GEORGE HALL MPR AND SUPPORT ROOMS PROJECT #19-143

ADDENDUM NO. 2

Date: November 19, 2021

Project: #19-143 George Hall MPR and Support Rooms Project
DSA #: 01-119574 41-26

SHEET:

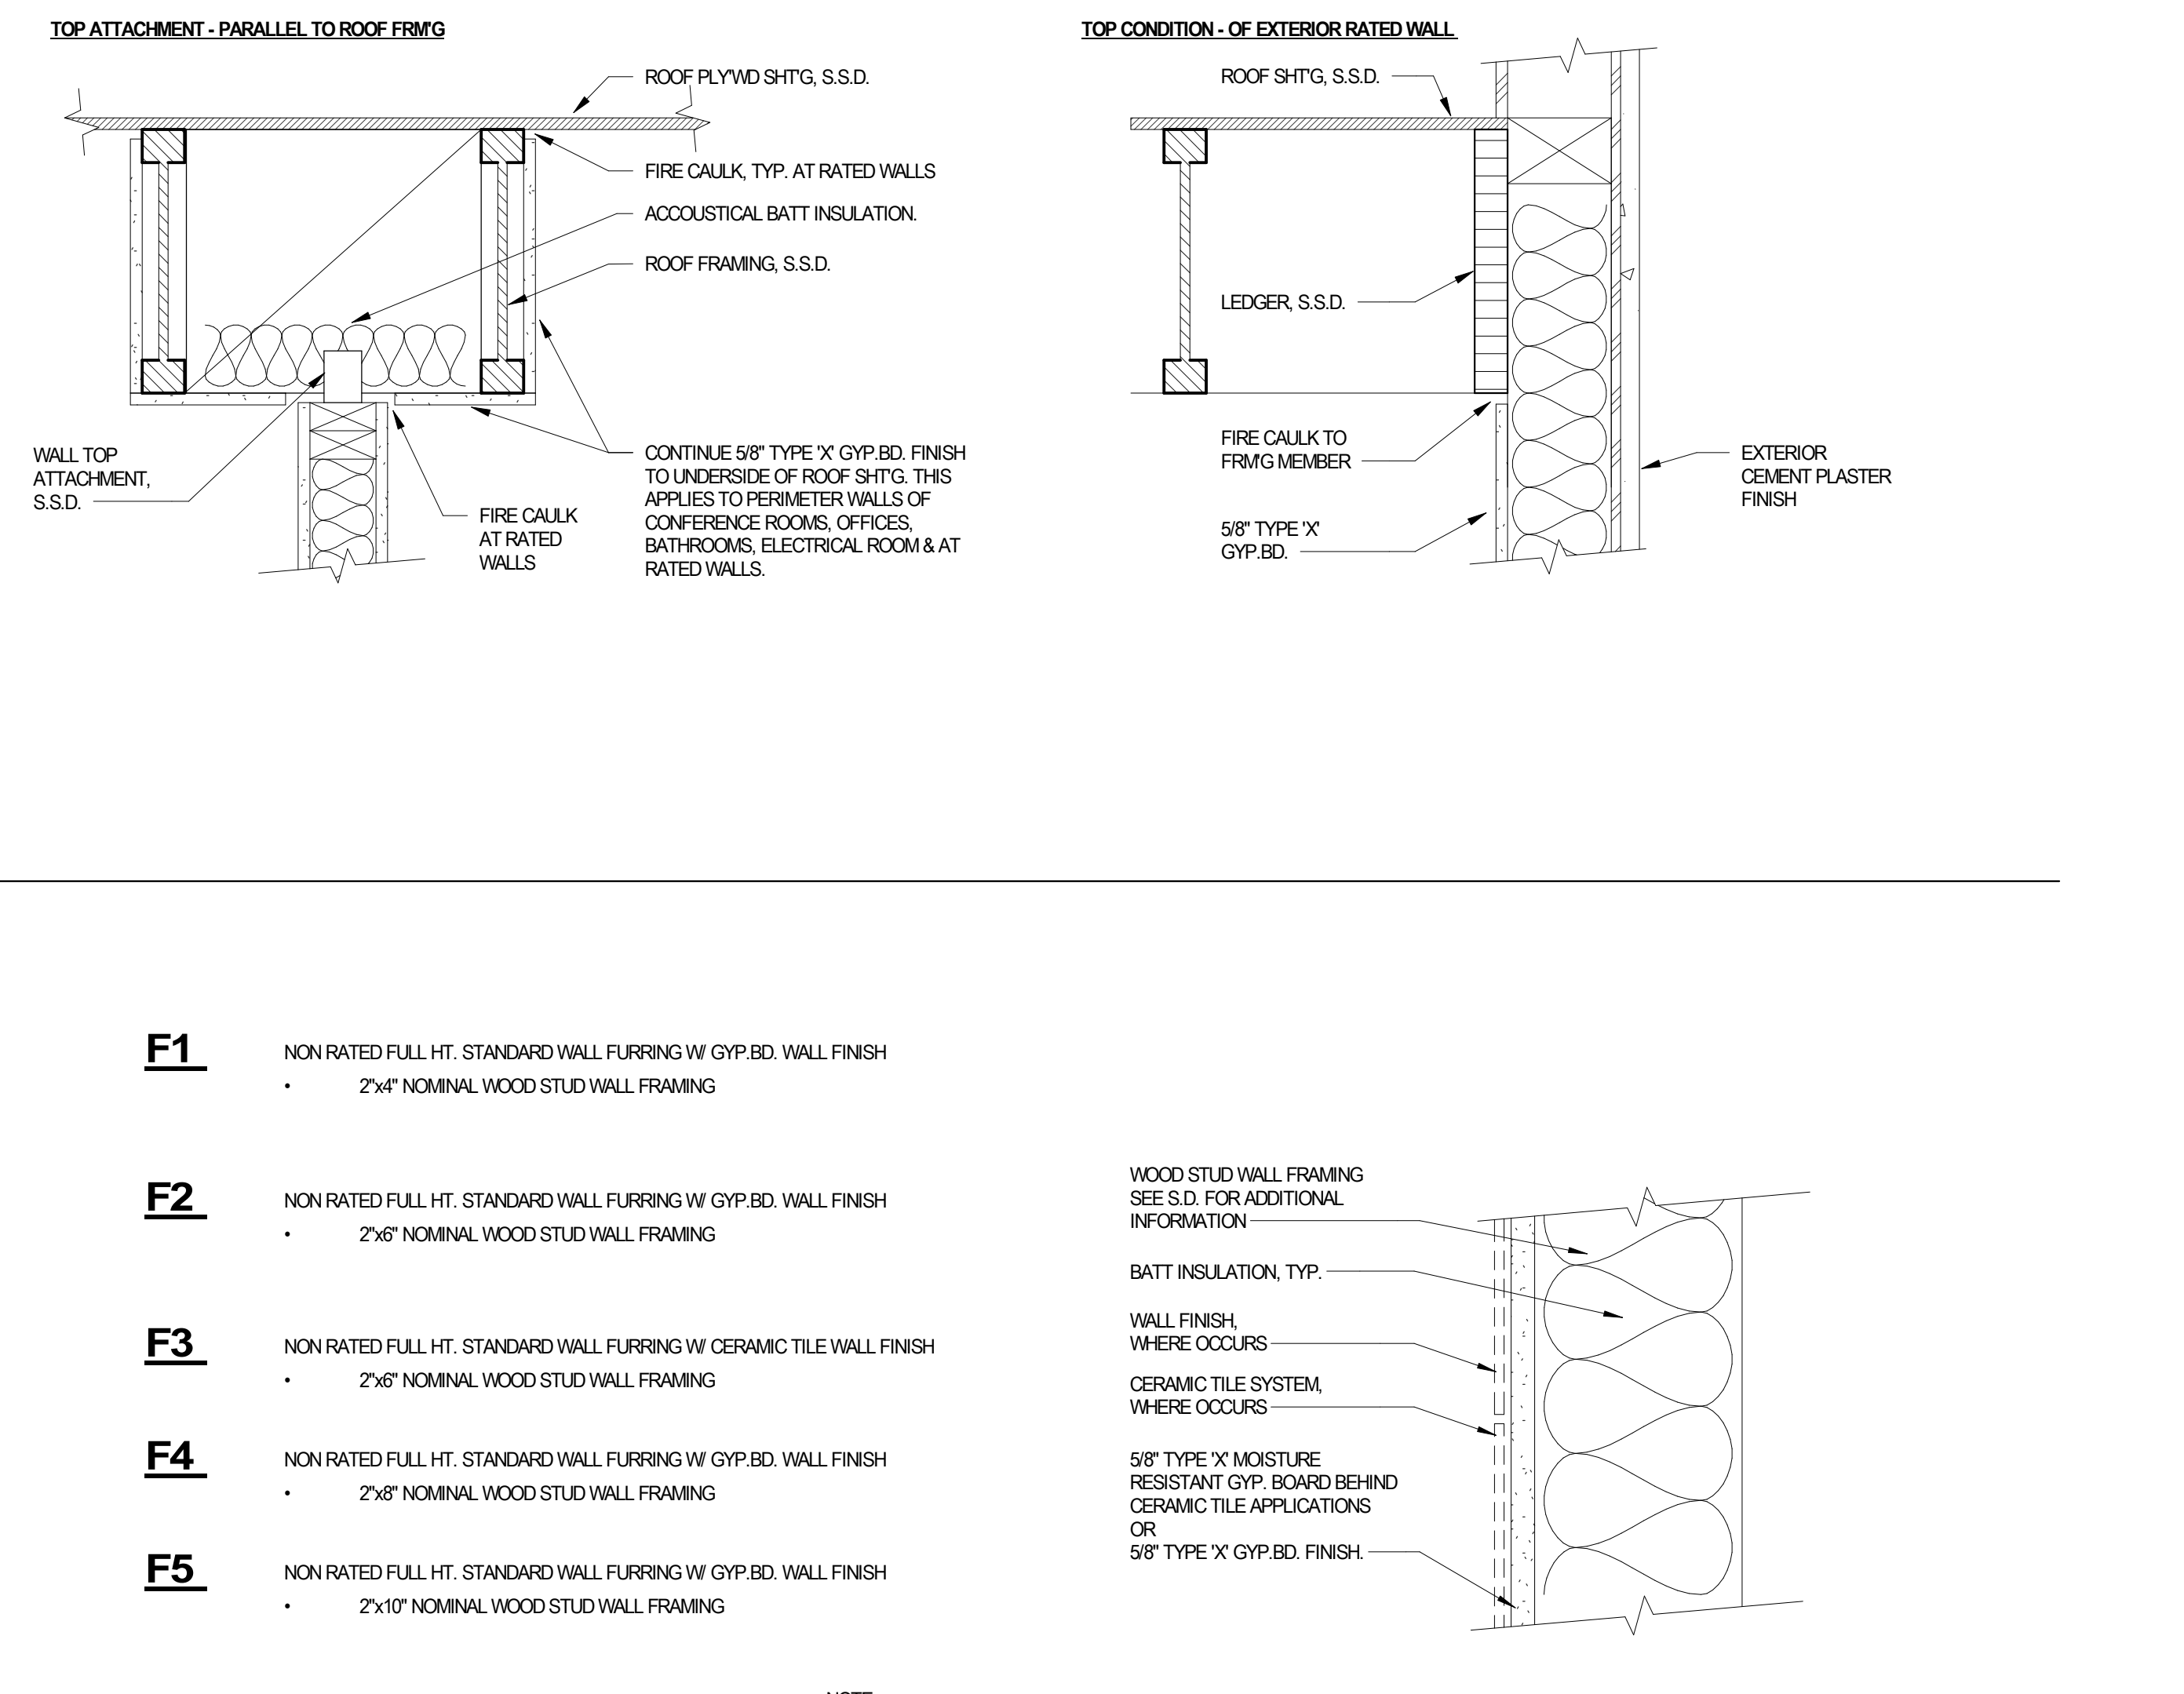
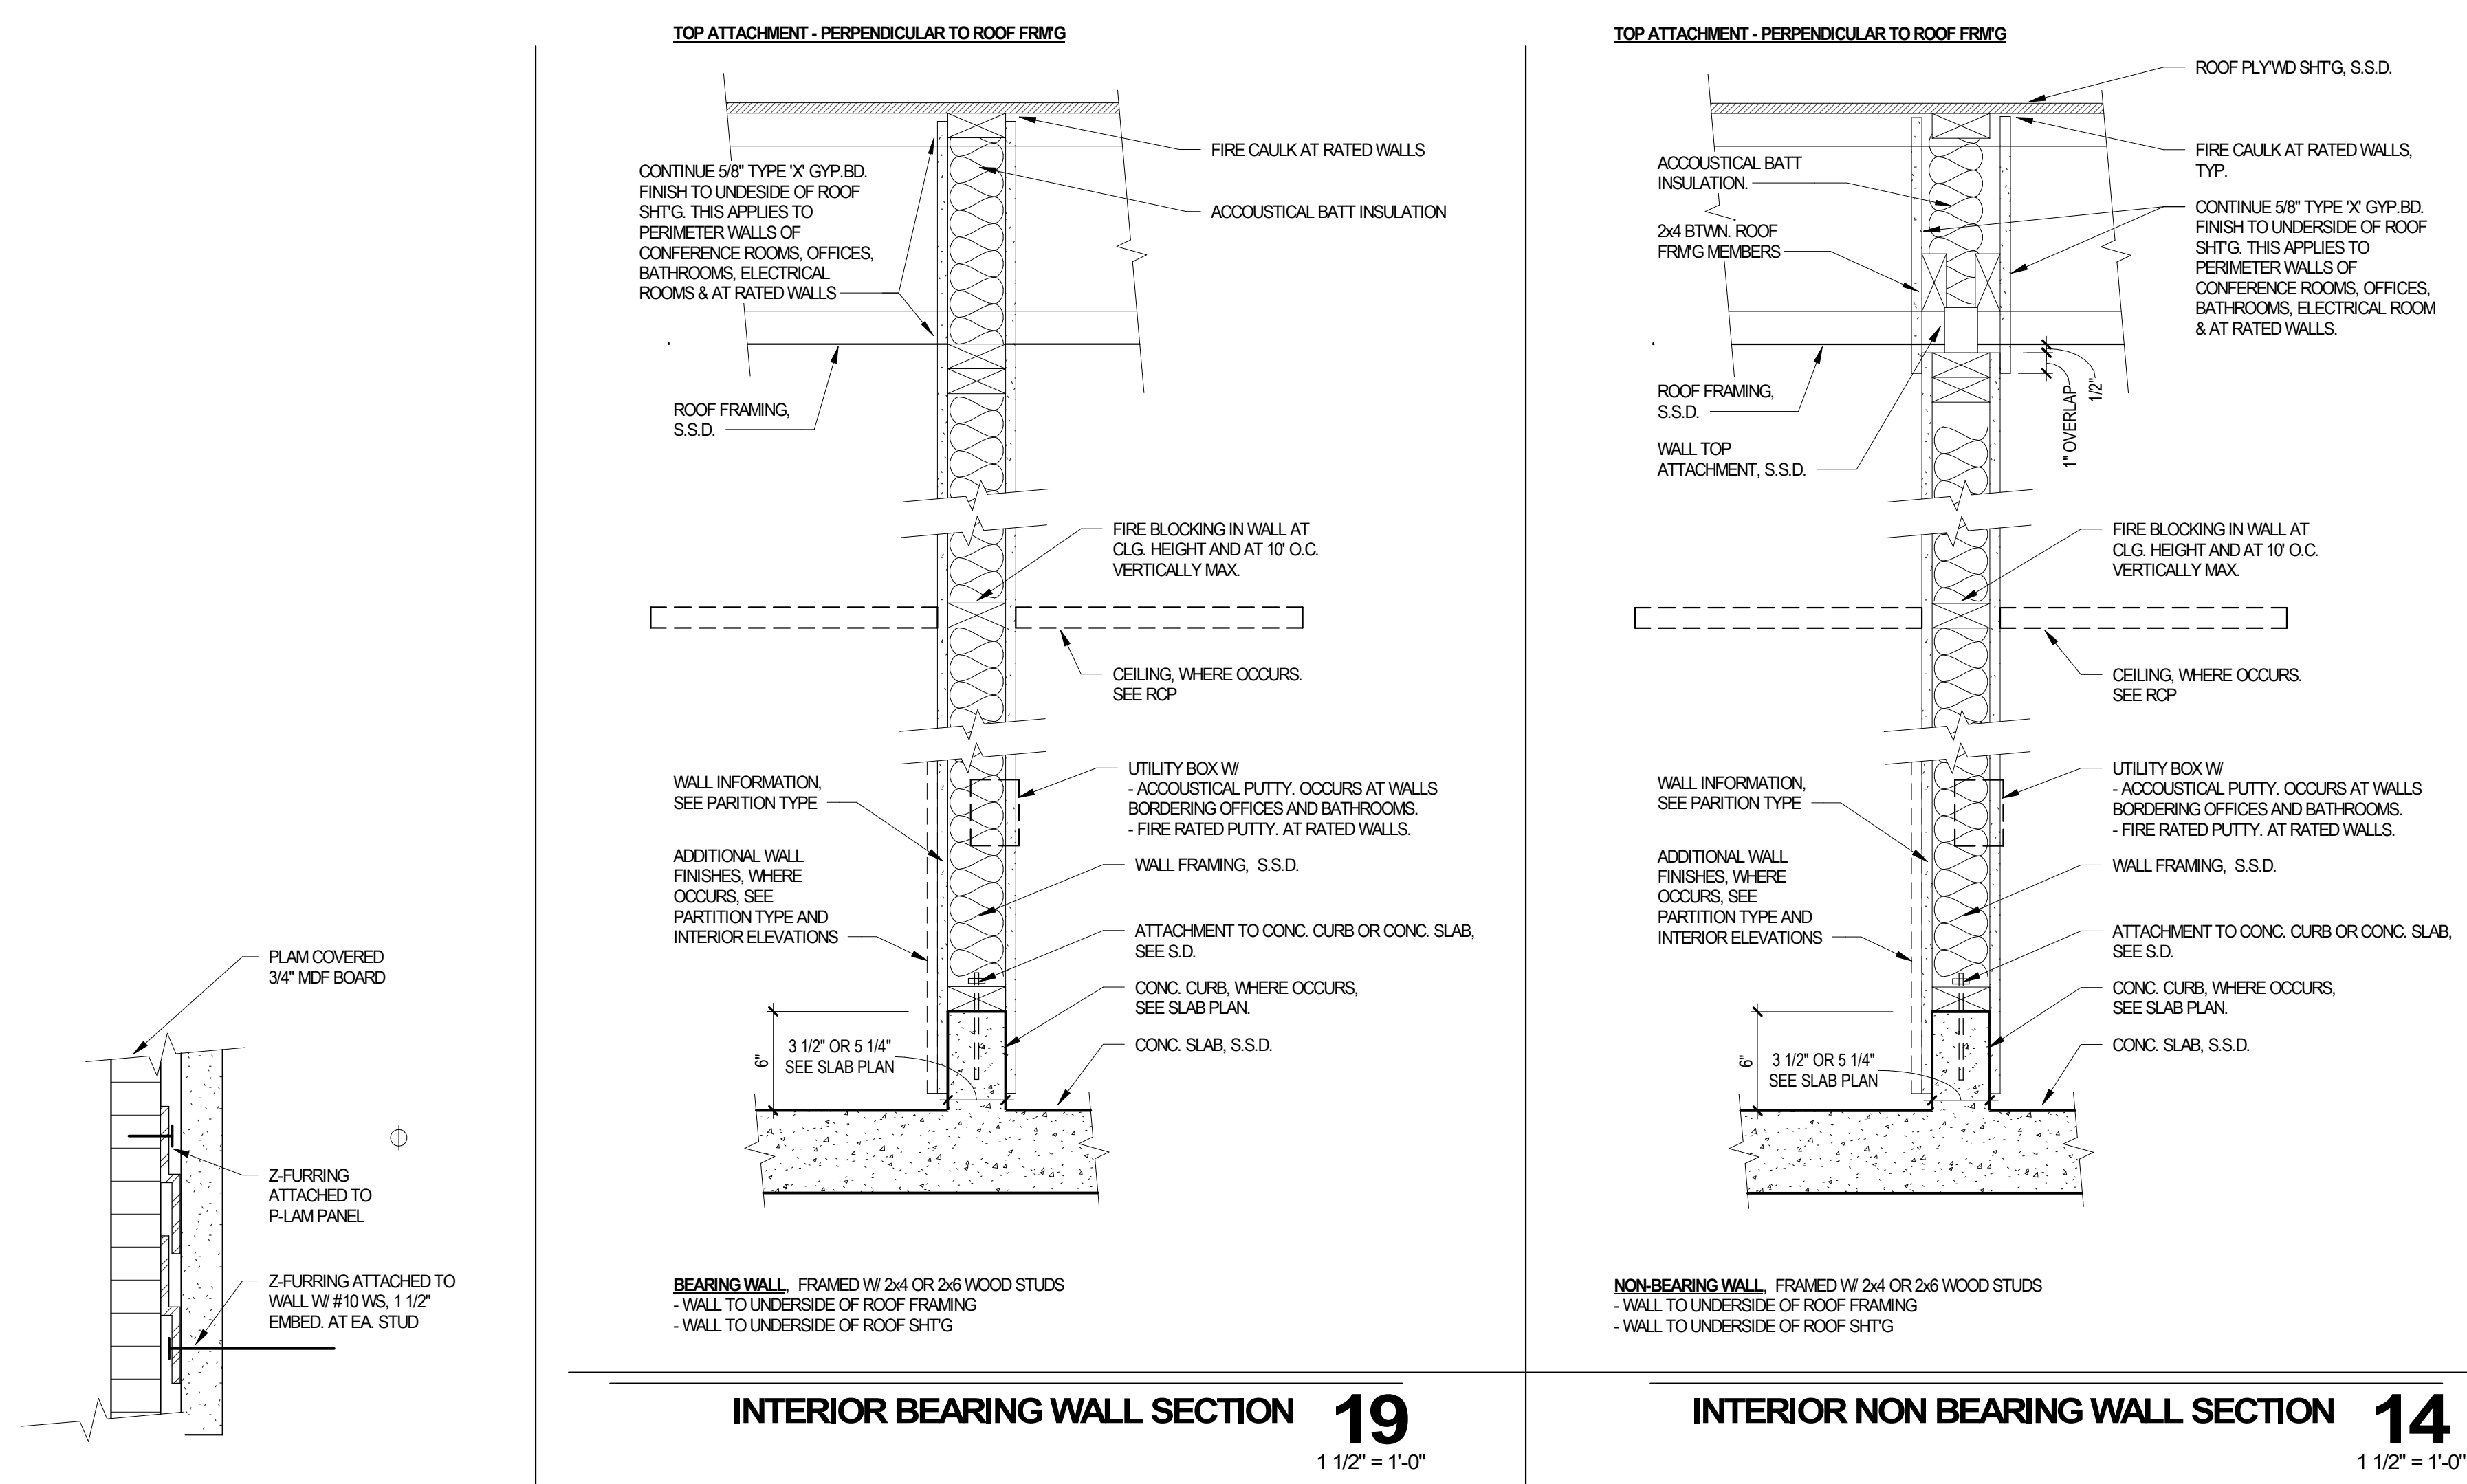
A. Revised detail with backing and insulation for window brake shape.

SHEET NAME:
MECHANICAL DETAILS

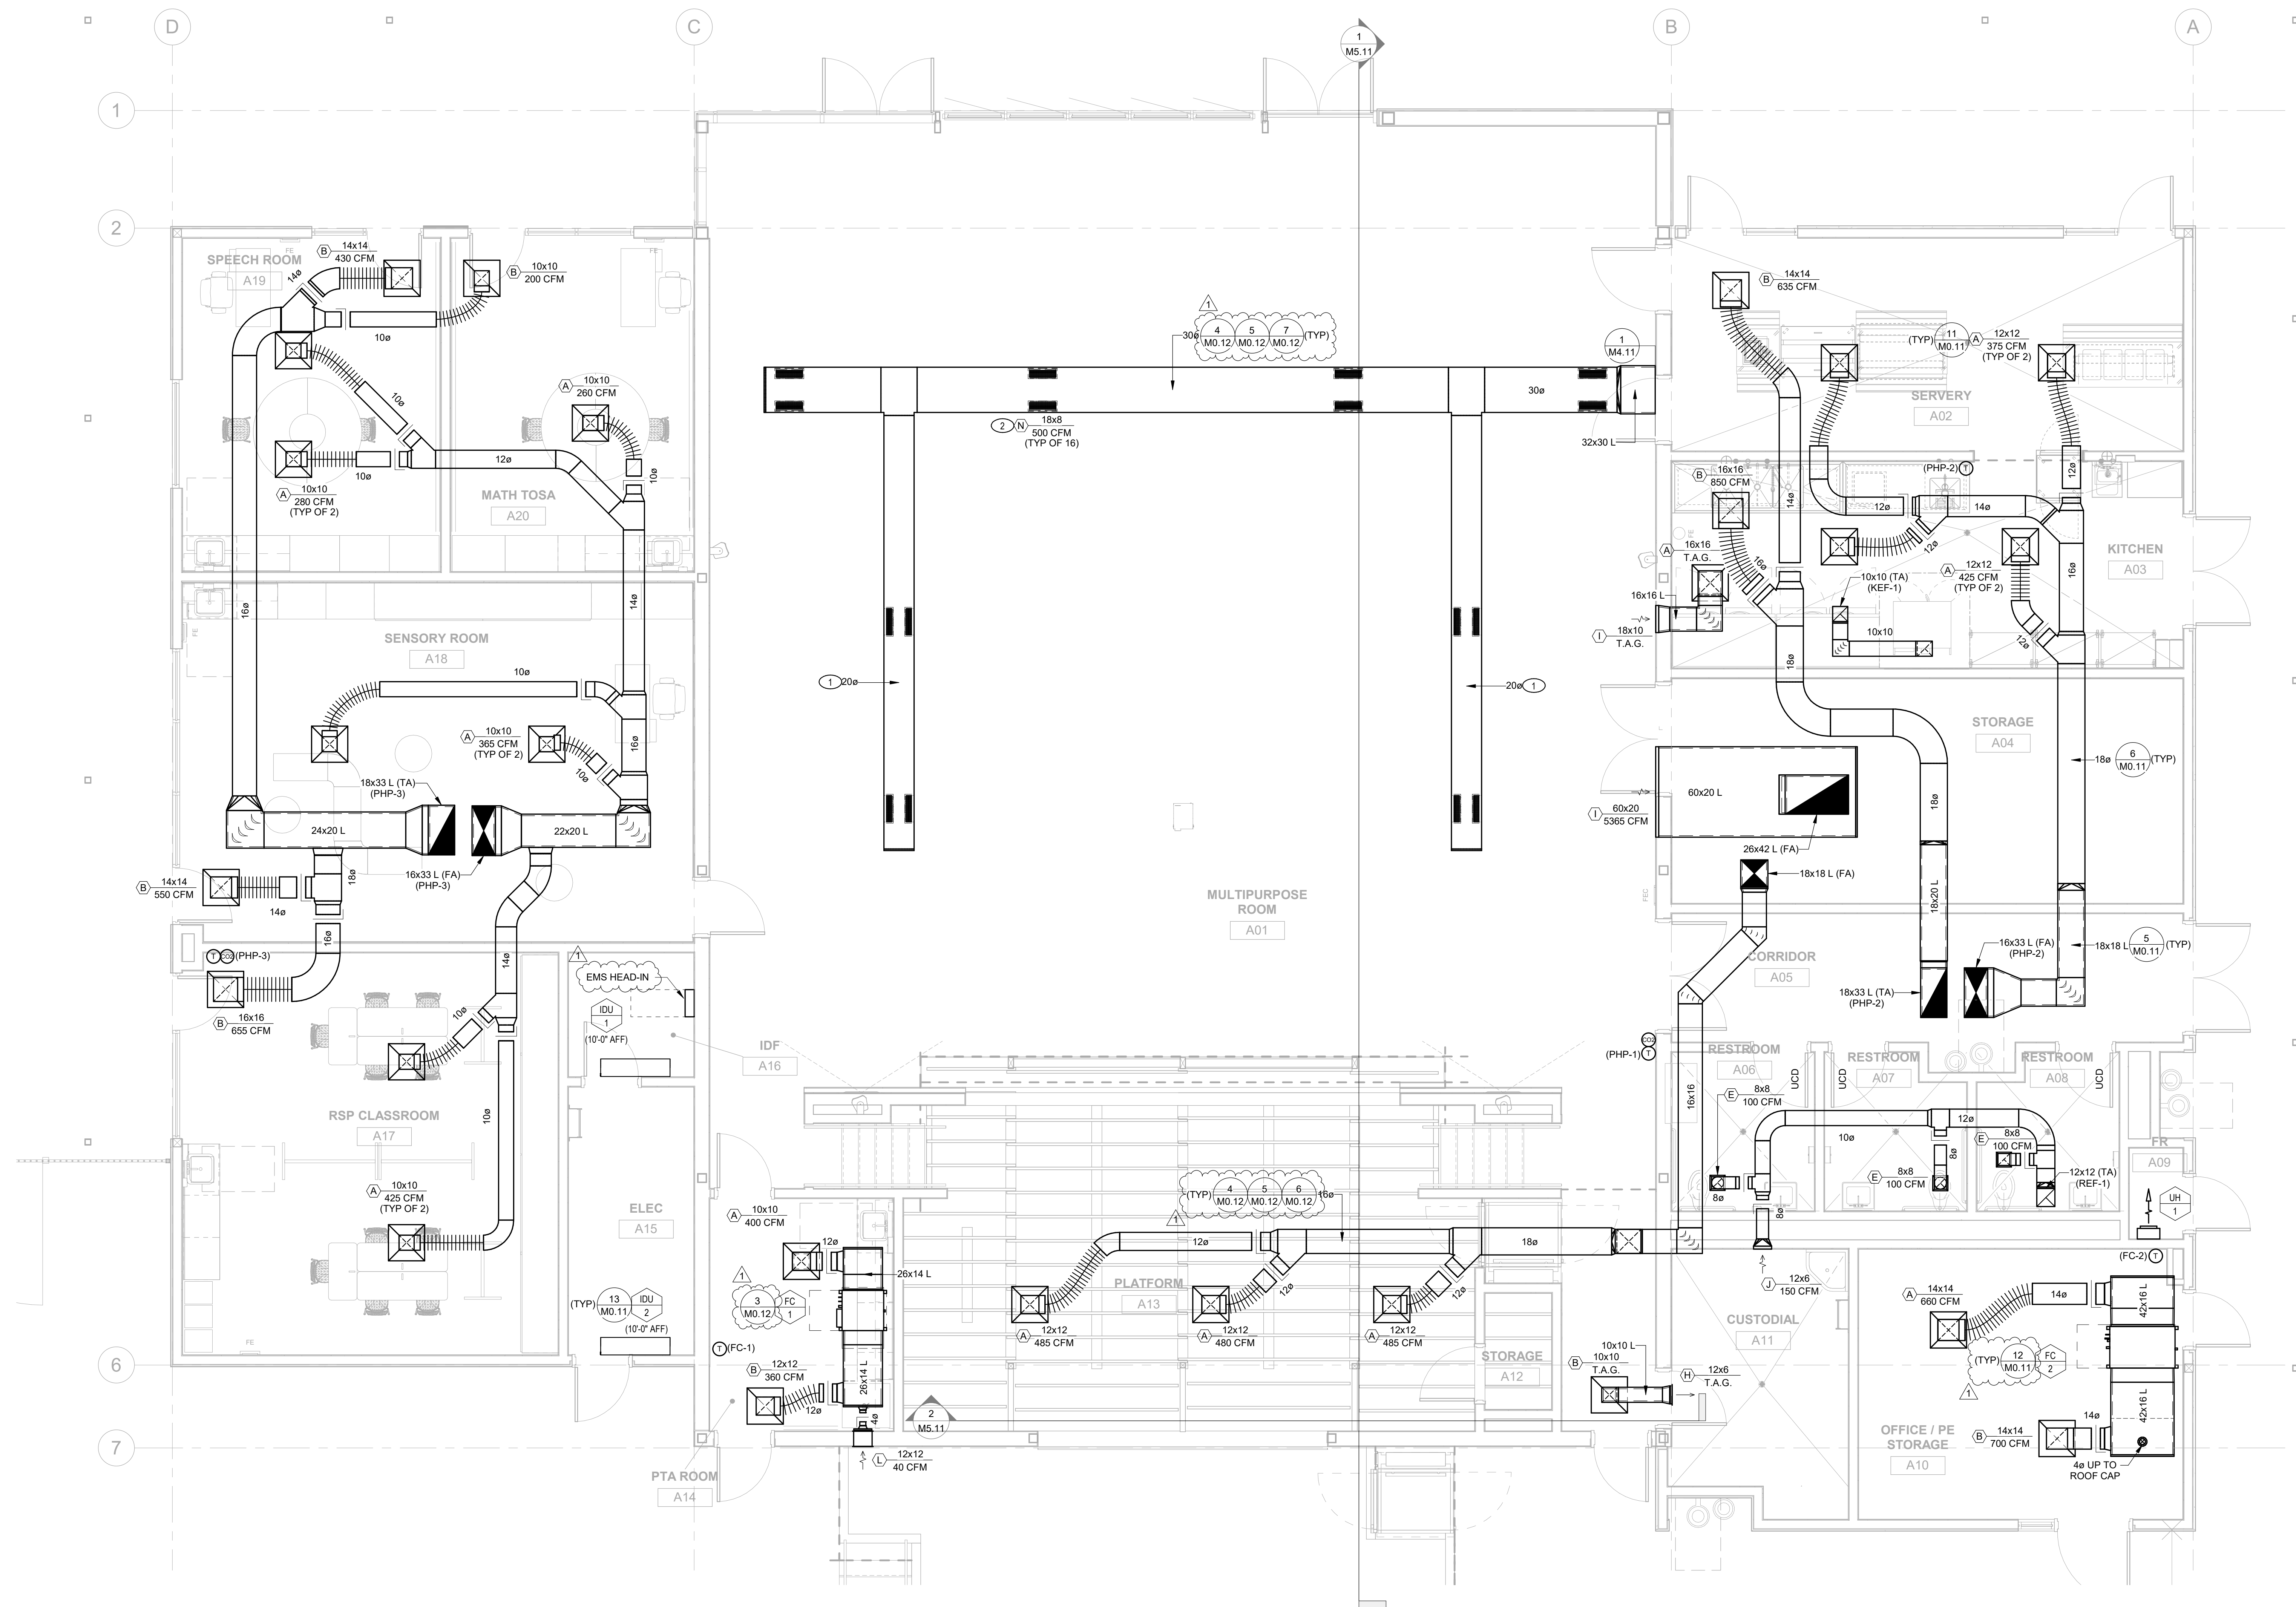
- A. Details 3, 4, 5, 6 & 7 have been added to this sheet.
